SERVICE No. 229A BULLETIN

Piper Aircraft Corporation
Lock Haven, Pennsylvania, U.S.A.

SUBJECT: Removal of Restriction to Airspeed Limits

MODELS AFFECTED: PA-30 Twin Comanche, Serial Nos. 30-853, 30-902 to 30-1159 incl.

SKETCH B

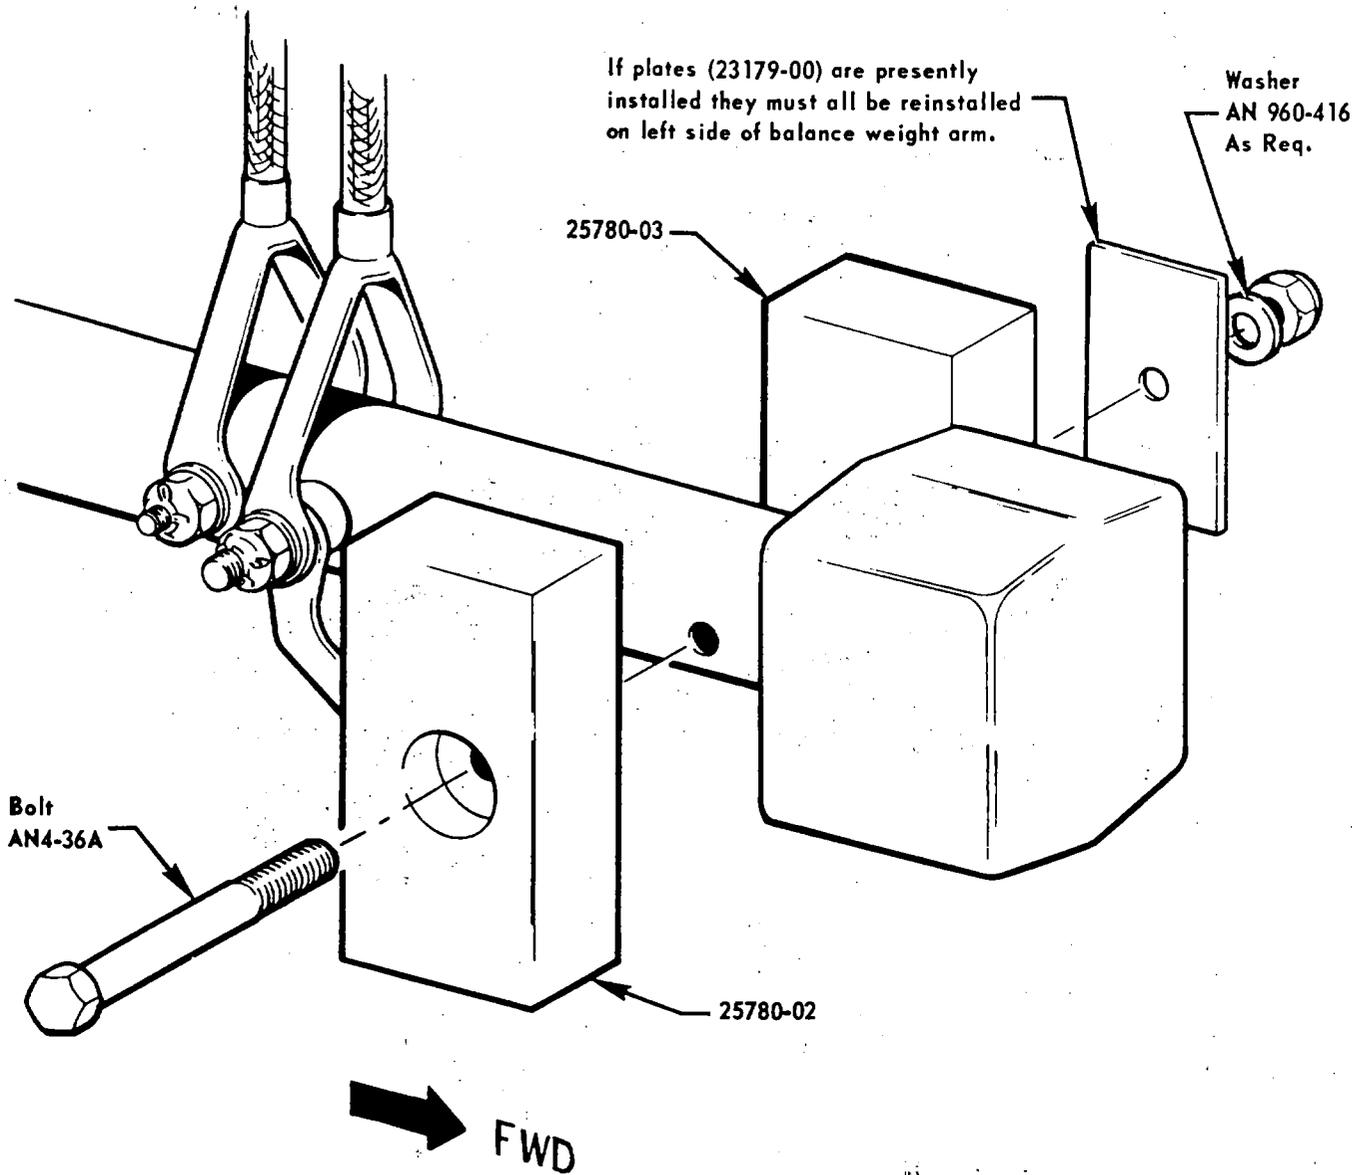
If alterations or repairs to the stabilator installation were made, the stabilator must be rebalanced in accordance with the balancing instructions and sketch "B" attached to this bulletin prior to the installation of Kit 757 044.

- c. Master check weight 23584-00 (weight 1.58 pounds) should be placed on top of balance weight 23594-00 with the side marked "FRONT" facing forward. If this is not enough weight to obtain static balance with the balance arm level, plates 23179-00 must be added to the forward balance weight attachment bolt until 100% static balance is obtained or until up to two plates more than that required for balance have been added. It should never be necessary to use more than eight plates. If a total of more than eight plates are necessary to obtain balance, the manufacturer should be consulted.

- e. After balancing is accomplished, the check weight should be removed and the front attachment bolt connecting the stabilator balance weight to the stabilator balance arm shall be removed and weights, part nos. 25780-02, 25780-03 and bolt AN4-36A and stabilator balance weight plates 23179-00 shall be installed at this attachment point. Stabilator balance weight, part no. 25780-02 shall be installed on the right side of the stabilator balance arm and stabilator balance weight, part no. 25780-03 and stabilator balance weight plates 23179-00 shall be installed on the left side of the stabilator balance arm.

Balance weight, part no. 25780-02 shall be installed such that the counter-bore and bolt head face outboard on the right side of the balance arm.

SKETCH A

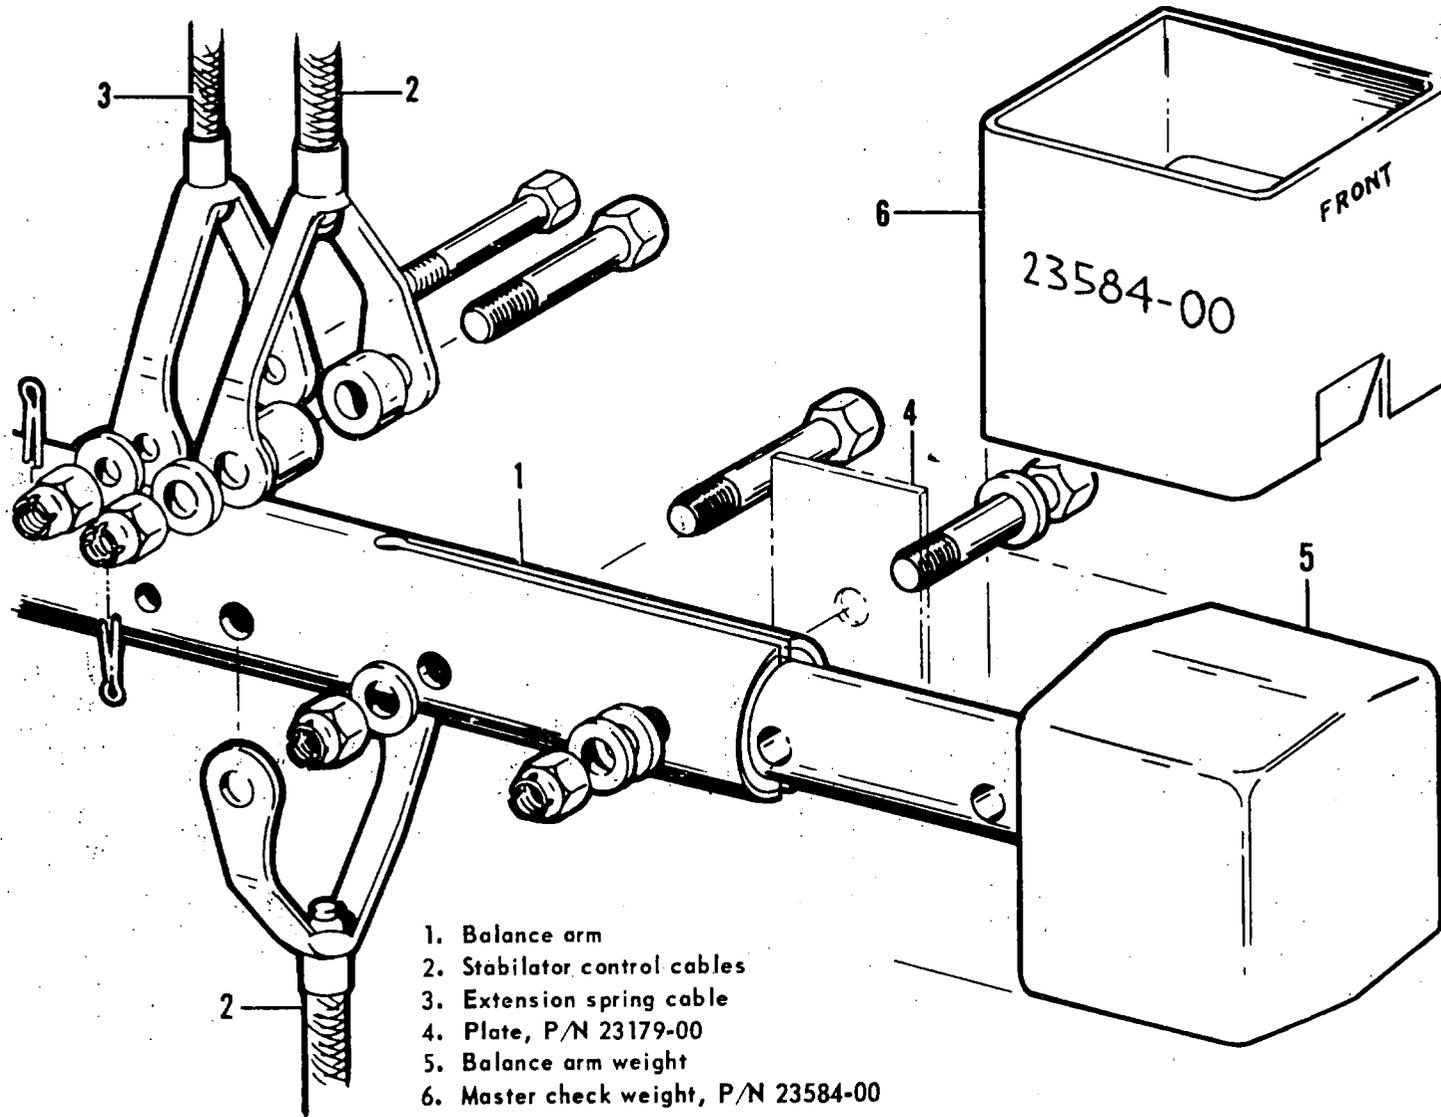
It has been determined that the installation of balance weights, part numbers 25780-02 and 25780-03 in addition to the standard balance weight, part number 23594-00, will eliminate this vibration, however, the original never-exceed airspeed limit, 245 MPH, must be reduced to 240 MPH.

A placard for the airspeed indicator, a revised Flight Manual, Stabilator Balance Weights and an AN4-36A bolt are contained in Kit 757 044. Information concerning the installation of this kit is contained on sketch "A" attached to this bulletin.
